Attachment A  
Section 92 Response,  
parts 1, 2, 3

25 January 2024

## Attachment A: Section 92 response

Table 1: Proposed Flood Hazard Condition – changes since lodgement and rationale

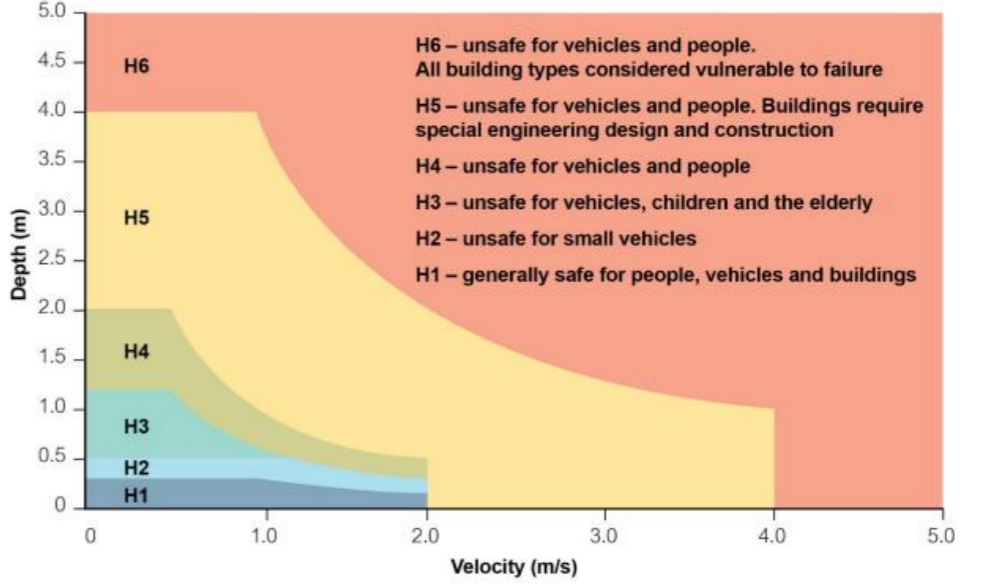
The table below sets out the Flood Hazard condition proposed at lodgment, the changes proposed as a result of a review of the condition carried out in December 2023 and our reasons for those changes.

Condition as lodged Sept 2023 (Appendix B, condition 10)	Proposed change to condition	Rationale for change from conditions as lodged
(a) The Project shall be designed to achieve the following flood risk outcomes:	The Project shall be designed to achieve the following flood risk outcomes:	N/A
<ul style="list-style-type: none"> <li>i. no increase in flood levels in a 1% AEP event for existing authorised habitable floors that are already subject to flooding or have a freeboard less than 150mm;</li> </ul>	<ul style="list-style-type: none"> <li>no increase in flood levels in a 1% AEP event for existing authorised habitable floors that are already subject to flooding or have a freeboard less than <del>150mm</del>500mm;</li> </ul>	<p>A site assessment was carried out to estimate the amount of freeboard at buildings that might be affected by flooding close to the proposed NoR boundary (refer Section 4 and the maps in Appendix 1 of the Supplementary Flood Hazard Assessment). When the freeboard was estimated, the majority of those existing floors assessed were either flooded or within 150mm of flooding. Changing to 500mm had a minor increase in the number of floors subject to this condition but the controlling criteria was typically the building with freeboard less than 150mm.</p> <p>The new criteria also provides better protection for relatively new buildings that may be constructed prior to lodgement of the OPW– which is relevant to NoRs near flooding within the Future Urban Zone.</p> <p>Increasing freeboard to 500mm for these types of buildings aligns with freeboard standards in the AC Stormwater Code of Practice for new builds.</p> <p>It is not intended to protect all future buildings – those constructed after the OPW are lodged are expected to set appropriate freeboard above the Post project flood level.</p>

<ul style="list-style-type: none"> <li>ii. no more than a 10% reduction in freeboard in a 1% AEP event for existing authorised habitable floors with a freeboard over 150mm;</li> </ul>	<ul style="list-style-type: none"> <li><del>no more than a 10% reduction in freeboard in a 1% AEP event for existing authorised habitable floors to maintain a minimum with a freeboard of over 150mm;</del></li> </ul>	<p>A percentage freeboard reduction is not needed if a freeboard of 500mm is utilised in criteria i.</p>

Condition as lodged Sept 2023 (Appendix B, condition 10)	Proposed change to condition	Rationale for change from conditions as lodged
<p>iii. no increase in 1% AEP flood levels for existing authorised community, commercial and industrial building floors that are already subject to flooding;</p>	<p>no increase in 1% AEP flood levels for existing authorised community, commercial, industrial and network utility building floors that are already subject to flooding or have a freeboard of less than 300mm;</p>	<p>This criterion has been introduced to address flood effects as these types of building are present in the Project area – such as east of SH1 (NoR4).</p> <p>Increasing the freeboard to 300mm for these types of buildings aligns with freeboard standards in the AC Stormwater Code of Practice for new builds.</p> <p>Given the potential town centre areas in the Future Urban Zone there is potential for more of them to be constructed prior to the lodgement of the OPW. The new criteria provides better protection for relatively new buildings.</p>
